Chapter 2 Errata – Revisions or Clarifications to Volume I, Draft Revised EIR

Based on the City of Santee’s (City’s) review and in response to the comments received, some text in the Draft Revised EIR for the Fanita Ranch Project (proposed project) has been clarified or amplified. Changes to the wording of impacts or mitigation measures and information added or deleted to the impact analyses and discussions are presented below with changes shown in underlined text (e.g., underlined text) and deletions indicated as strikethrough text (e.g., ~~strikethrough text~~) or in a descriptive form so that the original and revised text may be compared. Changes are presented by section and in the order they appear in the Draft Revised EIR. The sections where no revisions were made are not included in this chapter. Minor editorial changes have also been made to the Draft Revised EIR to improve readability or correct typographical errors, which are also summarized below. The chapters and sections referenced below refer to Volume I, Draft Revised EIR.

- Revised Figure 4.3-10, Regional Wildlife Corridors

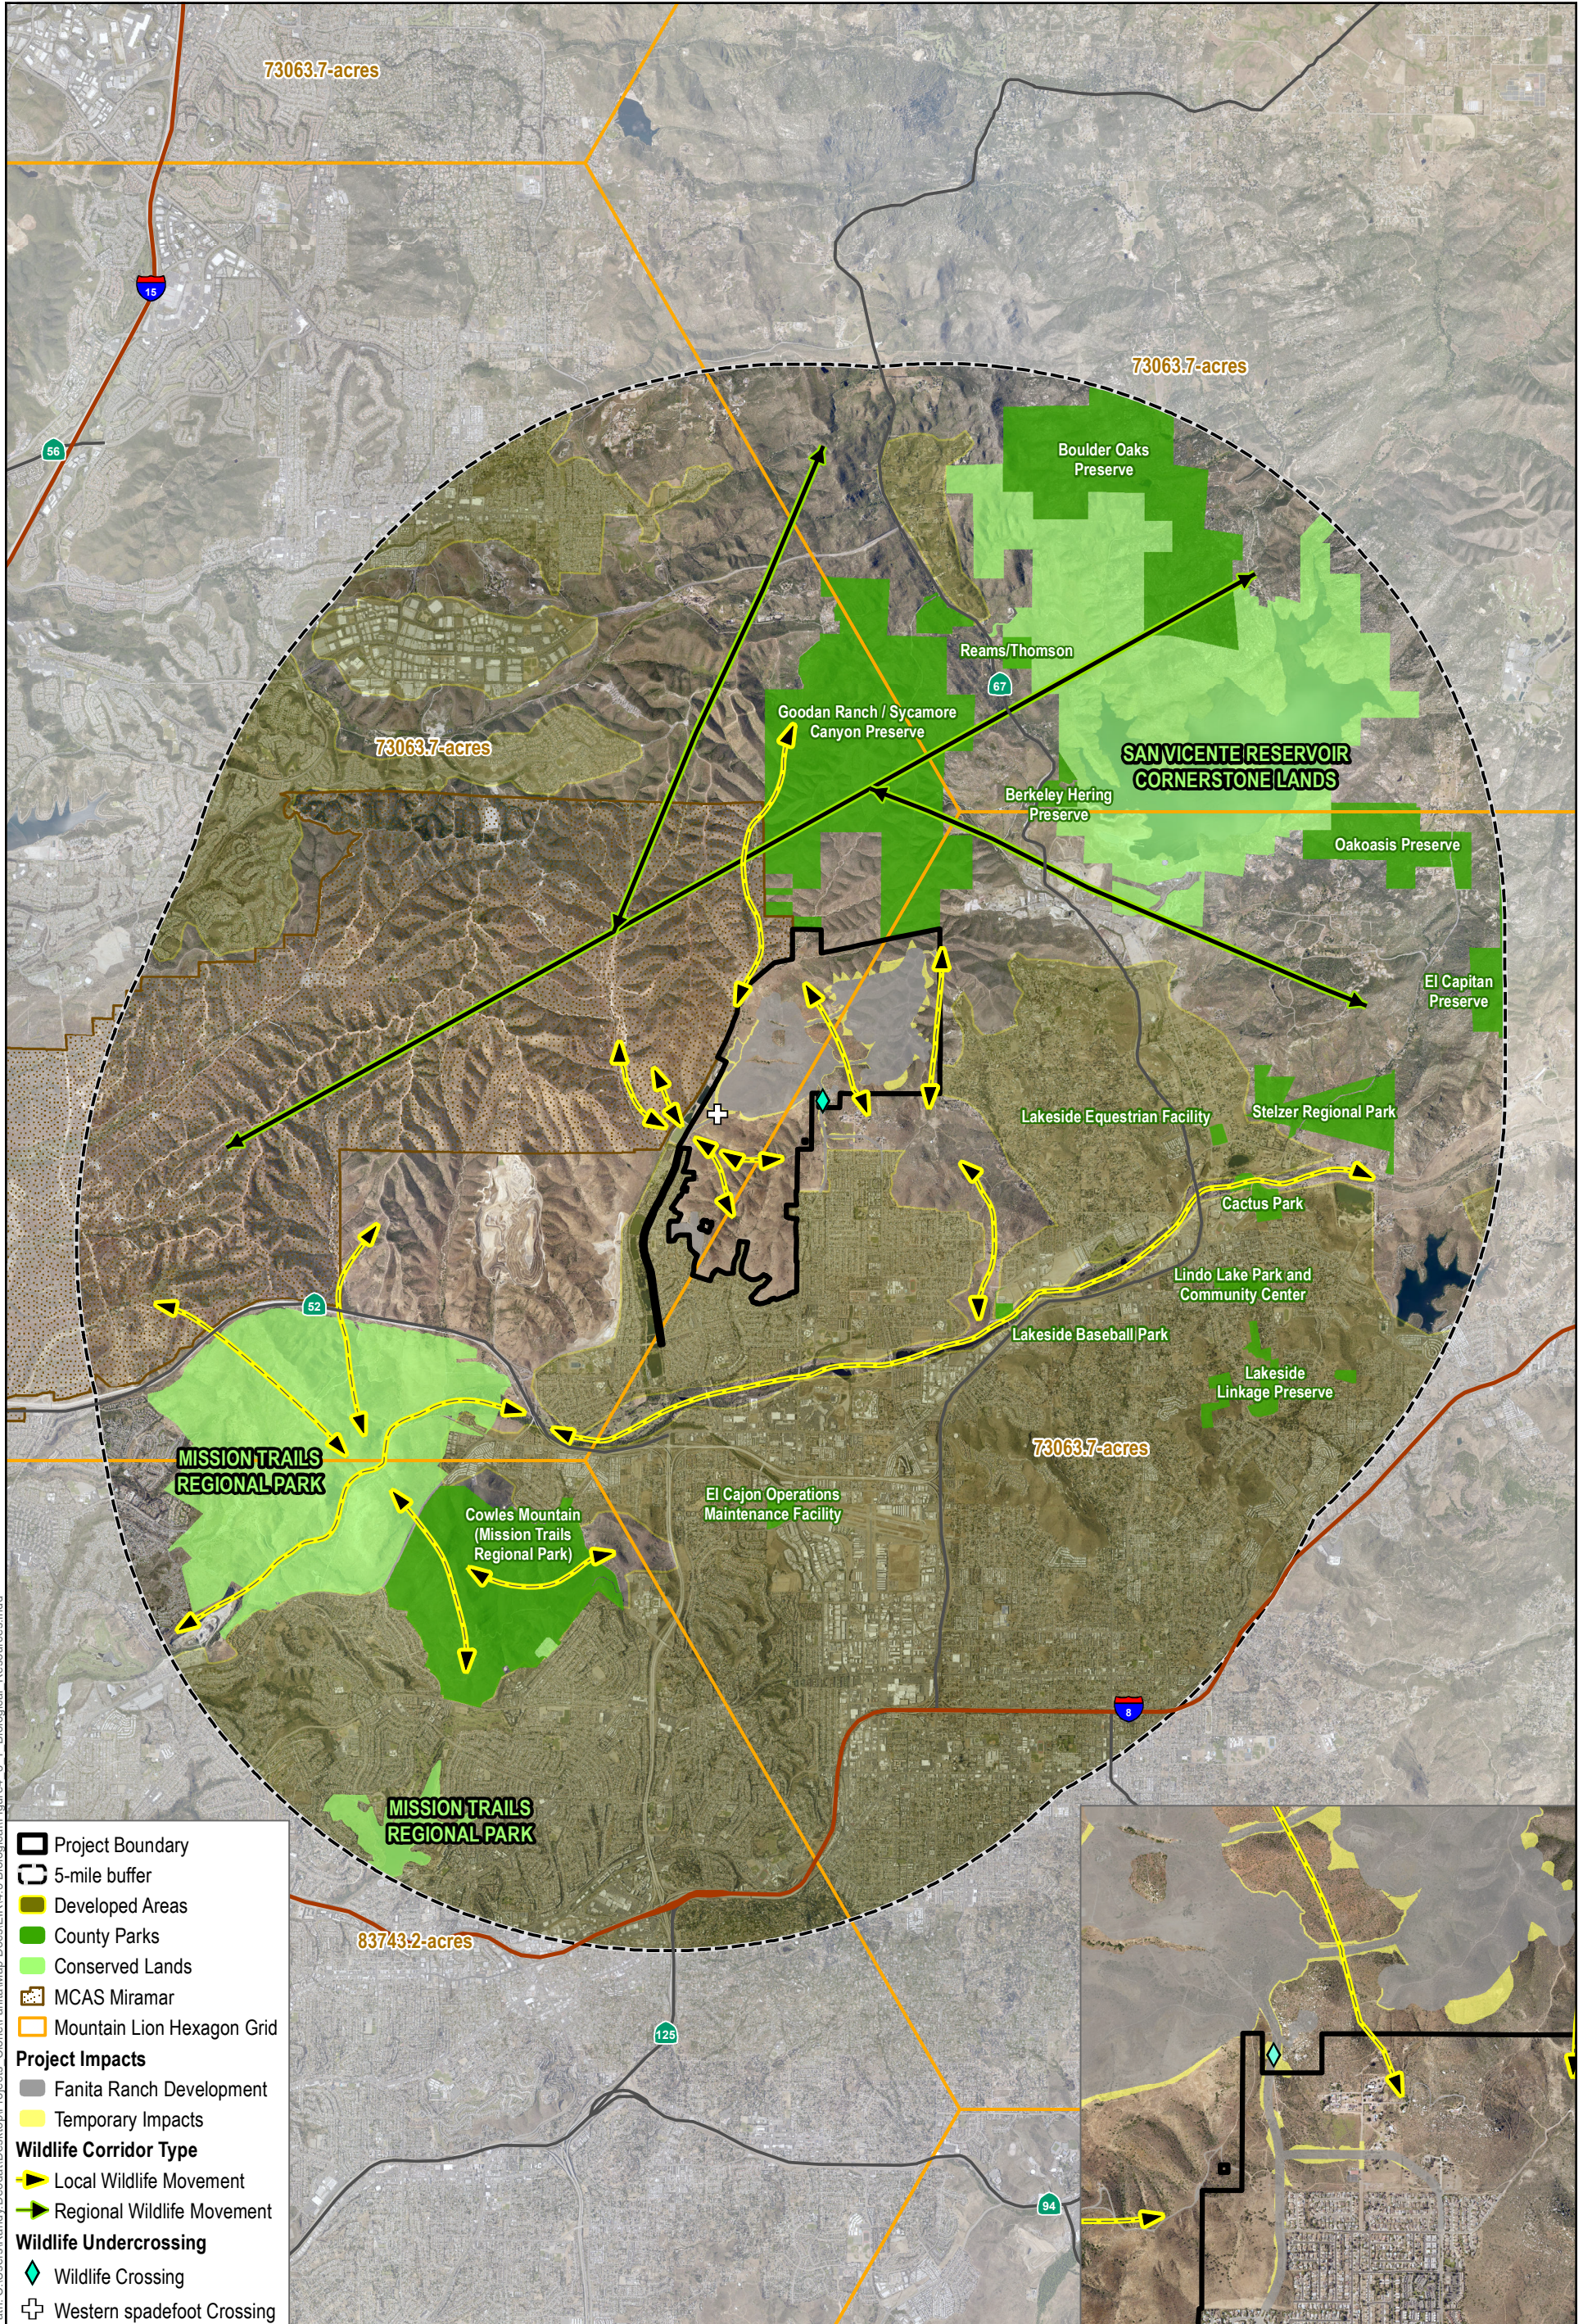
Figure 4.3-10, Regional Wildlife Corridors, was revised to include a representative male lion territory of approximately 73,000 acres. The revised figure is included as an attachment to this chapter.
